ENTERPRISE RIDE INTERIM CORRECTIVE ACTION PLAN
U.S. Consumer Product Safety Commission
March 2, 1984 [Revised 7/15/93]

SERVICE LETTER EN-01
ISSUED BY HUSS MASCHINENFABRIK
APRIL 10, 1984

SUBJECT: PSA 8559, CA842854, Review of State Inspections of Huss Enterprise and Manufacturer's Submissions

RE: ENTERPRISE - PARK/ROAD MODEL PIPE BRAKE VALVE

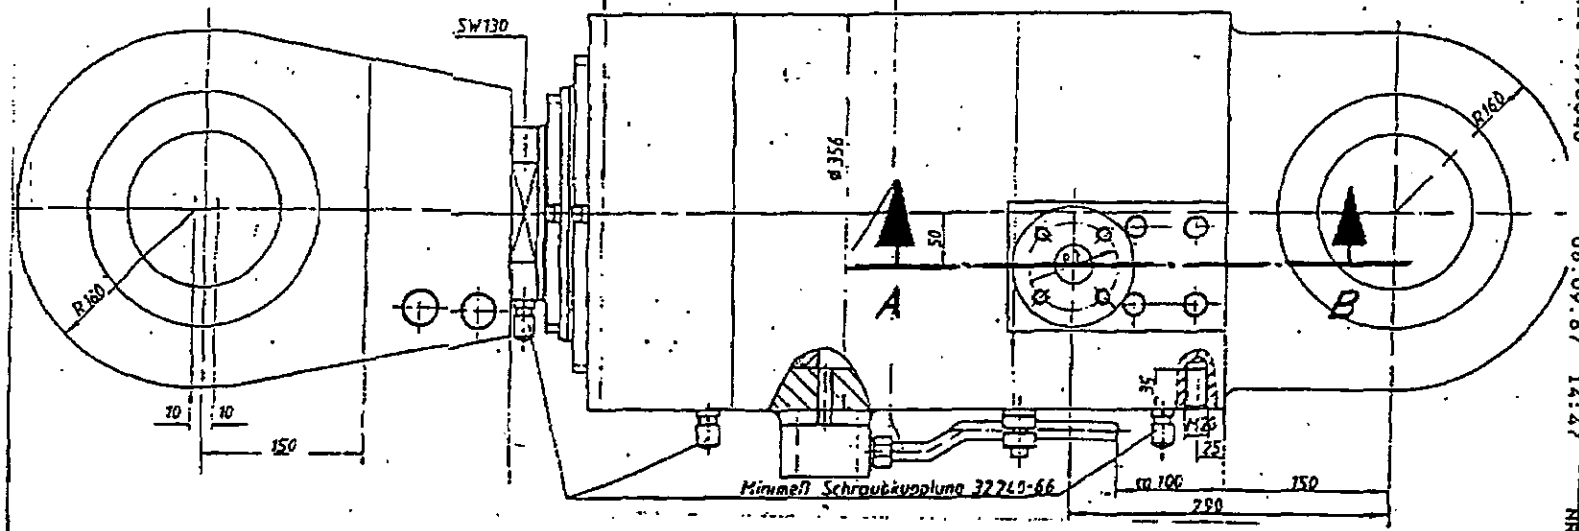
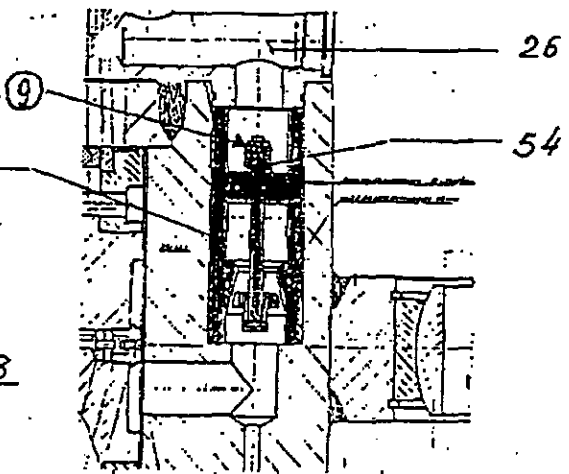
The built in pipe break valve (see attached drawing) prevents the drop of the wheel in case of a burst hose, etc. It should be visually checked at the annual inspection.

Figure 1 Location of the burst hydraulic hose.

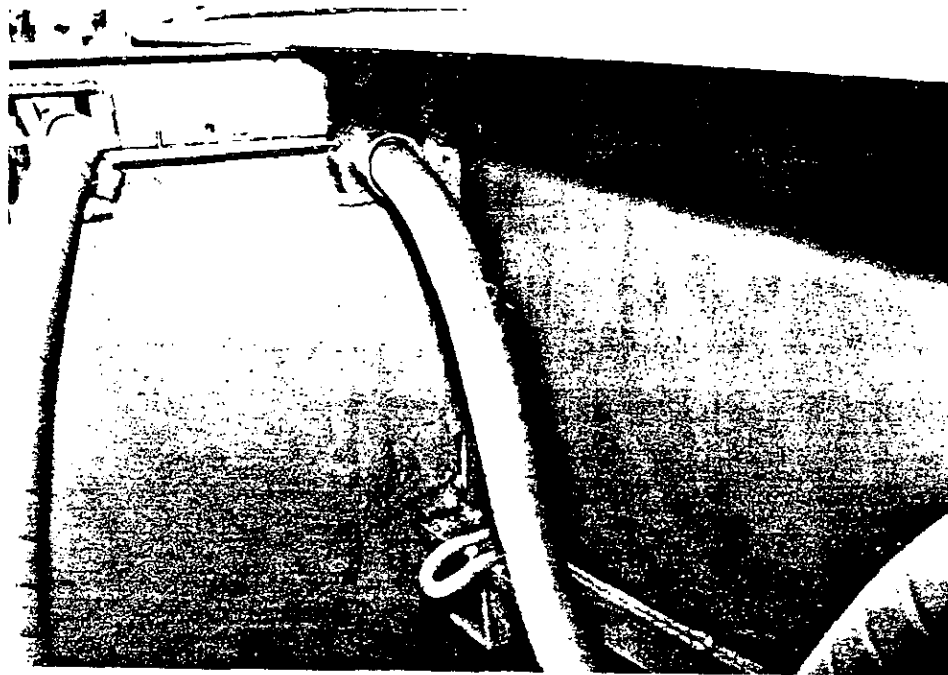
The examination found that one hydraulic hose had burst with an approximately 3-inch long breach which opened toward the ride's structure (Figure 1). This burst hose is embossed with: "AEROQUIP FC136-24 EXCEEDS SAE 100R12 MSHA 2G-9C/1 1086". According to reference (a), SAE 100R12 designates a heavy duty, high impulse, 4-spiral wire reinforced, rubber cover hydraulic hose. The last four digits (1086) indicate the probable date of manufacture is the 108th day of 1986. The ride's other hydraulic hoses (Figure 1) are similarly marked. Huss Maschinenfabrik's September 10, 1987, Service Letter EN-10 states that hydraulic hoses should be replaced after 4000 hours of operation. The hours of operation on the burst hose was not provided.

a) Overall view hydraulic hoses (the inner hose in the right center of the photograph is the one that burst).

b) View of burst hose showing location of hose breach.

Figure 4 Photograph of pipe break valve location.

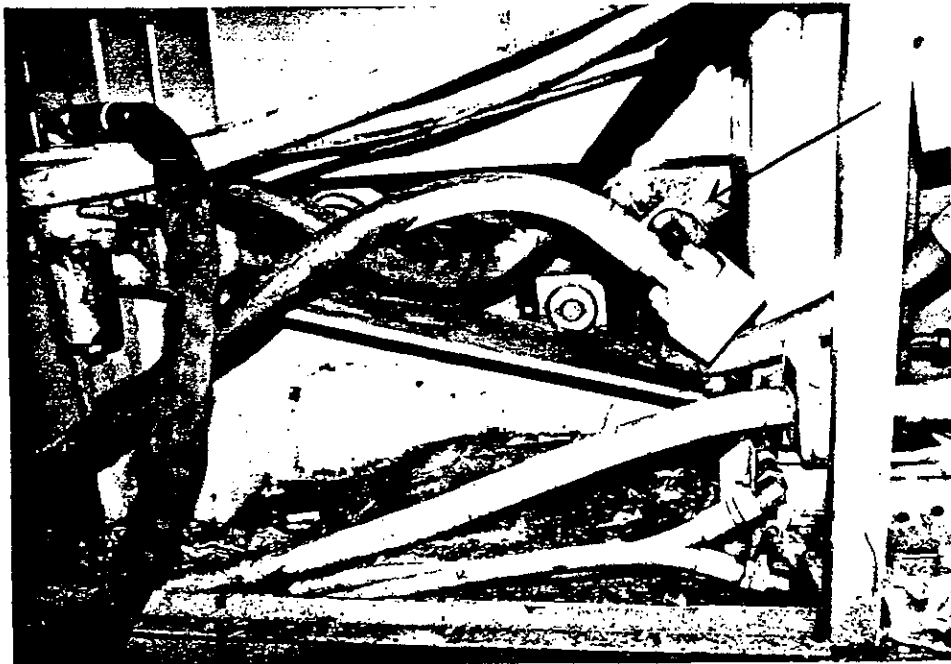
Camden Park personnel removed the pipe break valve from the ride (Figure 4). Figure 5 shows that the spring, screw, and nut of the pipe break valve are damaged and appear to have been damaged prior to the incident. This damage was sufficient to prevent proper functioning of the valve during the incident.

a) Covering over pipe burst valve.

b) Covering over pipe burst valve removed.

Figure 5 Photograph of damaged spring, cap screw, and nut removed from disassembled pipe break valve.

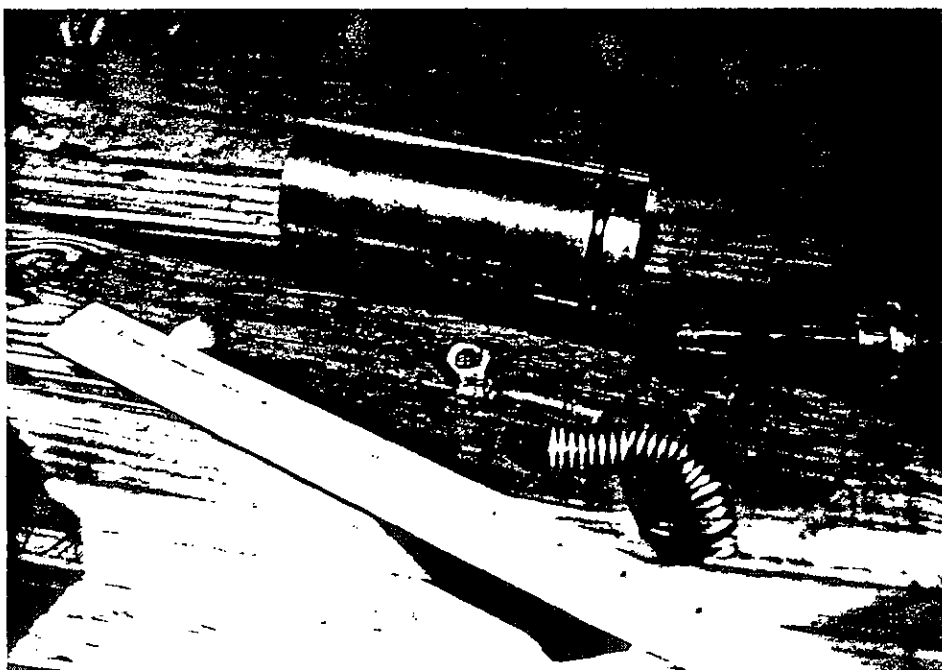
a) Pipe break valve as-removed from the ride.

b) Disassembled pipe break valve.

The pipe burst valve, which is meant to handle a sudden hydraulic pressure loss, was damaged at some unknown time prior to the incident and did not function properly during the incident. Huss Maschinenfabrik advises a visual pipe break valve check during the annual inspection, but they do not state how this is to be done. It is recommended that the visual check procedure be clarified by Huss Maschinenfabrik in a Service Letter.
